UNITED STATES
DEPARTMENT OF THE INTERIOR
BUREAU OF LAND MANAGEMENTFORM APPROVED
OMB NO. 1004-0135
Expires July 31, 2010**SUNDRY NOTICES AND REPORTS ON WELLS**
*Do not use this form for proposals to drill or to re-enter an abandoned well. Use form 3160-3 (APD) for such proposals.*5. Lease Serial No.
NMSF078502

SUBMIT IN TRIPLICATE - Other instructions on reverse side.1. Type of Well
☐ Oil Well ☒ Gas Well ☐ Other8. Well Name and No.
VANDEWART 12. Name of Operator
BP AMERICA PRODUCTION CO. Contact: CHERRY HLAVA
E-Mail: hlavacl@bp.com9. API Well No.
30-045-23823-00-S13a. Address
200 ENERGY COURT
FARMINGTON, NM 874013b. Phone No (include area code)
Ph: 281.366.408110. Field and Pool, or Exploratory
BASIN DAKOTA

BP - San Juan Wellwork Procedure

Re: Permanent Abandonment
Well: 1 Vandewart

Proposed Wellbore Diagram

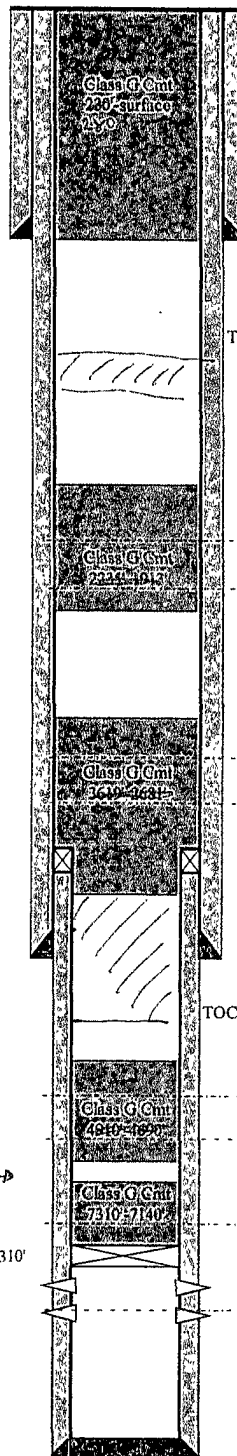
1. Plugging operations authorized are subject to the attached "General Requirements for Permanent Abandonment of Wells on Federal and Indian Lease."
2. Farmington Office is to be notified at least 24 hours before the plugging operations commence (505) 564-7750.
3. The following modifications to your plugging program are to be made:
 - a) Place a cement plug from 6320' – 6220' to cover the Gallup top.
 - b) Place the Mesaverde plug from 4744' – 4644'.
 - c) Place the Chacra/ 7" Casing Shoe/4 ½" Liner Top/Pictured Cliffs/Fruitland plug from 3844' – 2667'.
 - d) Place the Kirtland/Ojo Alamo plug from 2259' – 1977'.
 - e) Place the Surface plug from 280' to surface.

You are also required to place cement excesses per 4.2 and 4.4 of the attached General Requirements.
